APPENDIX C6:
Comments Received

RE: SARAO'S COMMENTS ON KOTULO TSATSI ENERGY PV1 SCOPING REPORT, NORTHERN CAPE PROVINCE.

ACCEPTANCE OF THE SCOPING REPORT FOR THE PROPOSED KOTULO TSATSI ENERGY PV1 FACILITY IN THE NAMAKWA DISTRICT MUNICIPALITY, NORTHERN CAPE PROVINCE

COMMENT: DRAFT SCOPING REPORT KOTULO TSATSI SOLAR DEVELOPMENT PROJECTS; PV 1; PV 3 & PV 4: ENVIRONMENTAL IMPACT ASSESSMENT AND PUBLIC PARTICIPATION PROCESS

Figure 1: Source - SEA www.csir.co.za & DEA

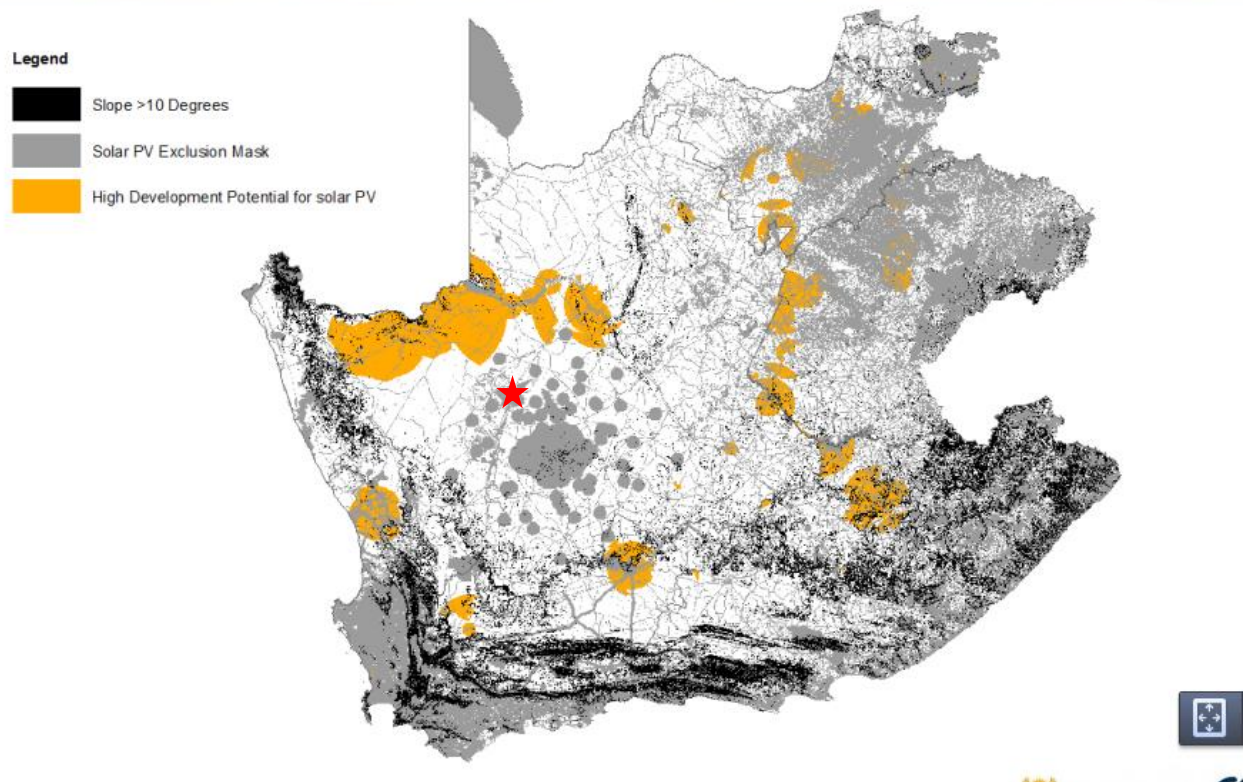
Below is a map extracted from the CSRI & DEA SEA, the red star is the approximate location of the proposed PV1, PV2 & PV3. It is clearly outside of high development potential areas and within an exclusion area. The grey exclusions in this case relate to SKA reserve area, sensitive wetland drainage patterns and ecological corridors.

Figure 2 below is extracted from the CSRI & DEA SEA. It illustrates the Pofadder potential development area in relation to the approved site (red star). Clearly the site is outside of the area amongst exclusion mask criteria.
